Purdue University Responses to PURDUE UNIVERSITY – REQUEST FOR ADDITIONAL INFORMATION REGARDING THE PURDUE UNIVERSITY REACTOR LICENSE RENEWAL APPLICATION (TAC NO. ME1594), RESPONSES TO LETTER DATED August 29, 2014.

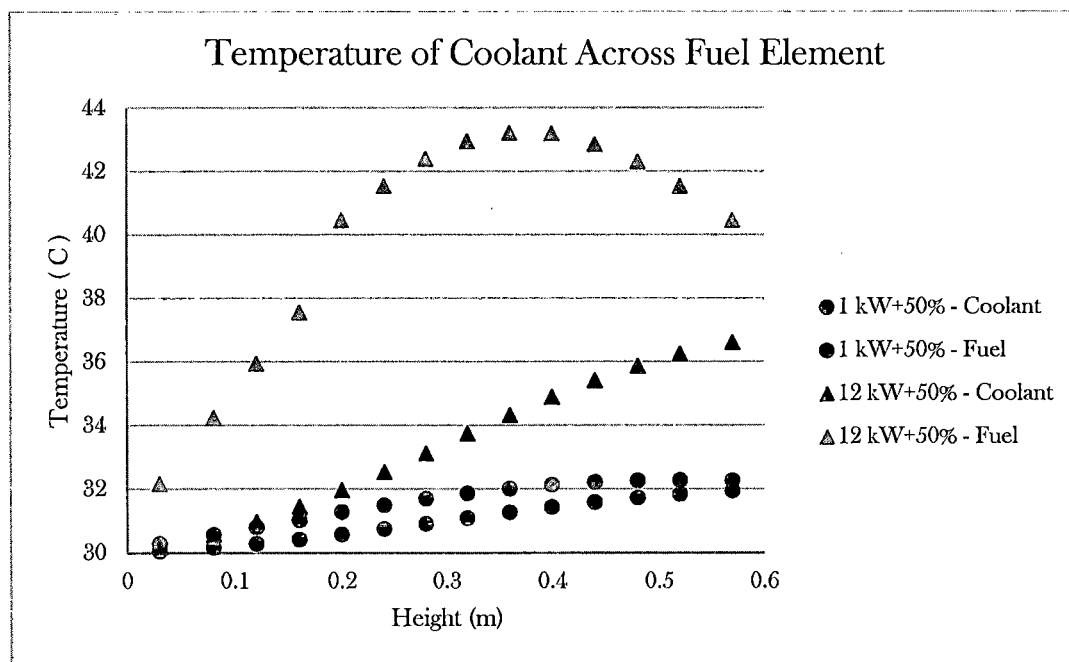
Major inconsistencies are noted throughout the SAR [safety analysis report] related to calculation assumptions for initial and requested maximum licensed power under the PUR-1 license renewal. For example, SAR Section 13.2.2, p. 13-11, references current licensed power of 1 kW [kilowatt] for a reactivity insertion with scram. Please clarify the desired maximum licensed power level requested and ensure this power level, including any uncertainty in reactor power, is consistently applied in the safety analyses for the license. Please provide an updated evaluation of a safety analysis that explains all analyses, assumptions and conclusions at the requested maximum licensed power level.

Additional clarification to RAI 63 is needed. Provide responses to the questions below:

- (a) Provide an answer to RAI 63 or indicate if the answer to RAI 63 is provided in the responses to RAIs 62 and 65 in your letter dated January 31, 2012.

- (b) Table 4-21 in the revised PUR-1 SAR, Section 4.6 indicates that for 1 kW and 12 kW, the maximum fuel temperatures for the limiting fuel plate (31.92 and 39.1 degrees Celsius (C)) are lower than the maximum clad temperatures (43.42 and 43.4 degrees C). Discuss the physical phenomena that would result in these temperature values.

Radioiodines released from Plate 1348 into Facility Air.

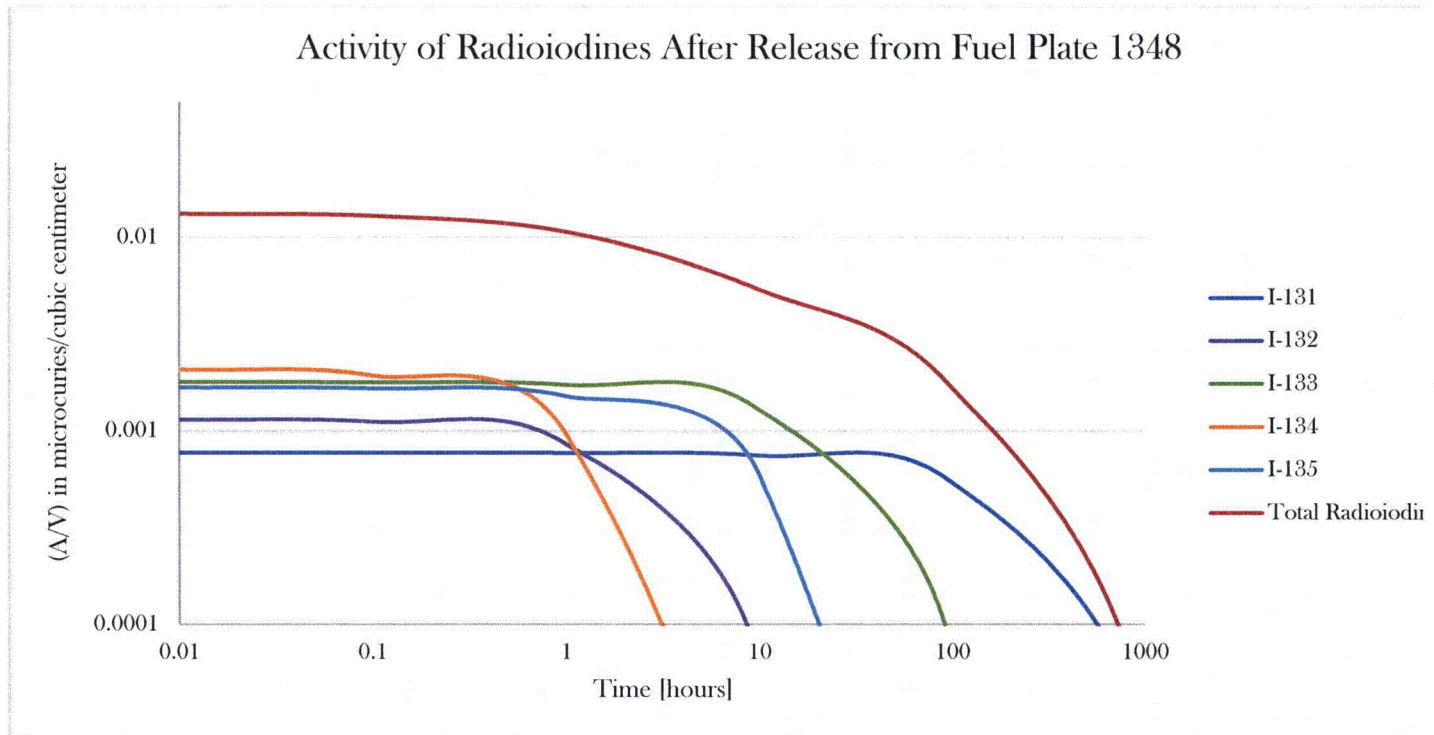
**12. Provide an MHA safety analysis that explains all analyses, assumptions and conclusions at the requested licensed power level for the maximum potential estimate of the total radioactive fission product release after the failure of one side of one fuel plate. Discuss methodological assumptions associated with the following analytical steps:**

The calculated values for each of the five iodine isotopes of concern are shown in below.

Isotope	Fractional Yield	Half-life (sec)	Decay Constant	Activity [Ci]
I-131	0.0289	$6.95 \times 10^5$	$9.98 \times 10^{-7}$	0.103
I-132	0.0431	$8.21 \times 10^3$	$8.44 \times 10^{-5}$	0.154
I-133	0.067	$7.49 \times 10^5$	$9.26 \times 10^{-6}$	0.239
I-134	0.0783	$3.16 \times 10^3$	$2.20 \times 10^{-4}$	0.280
I-135	0.0628	$2.37 \times 10^4$	$2.93 \times 10^{-5}$	0.224
Total				1 Ci
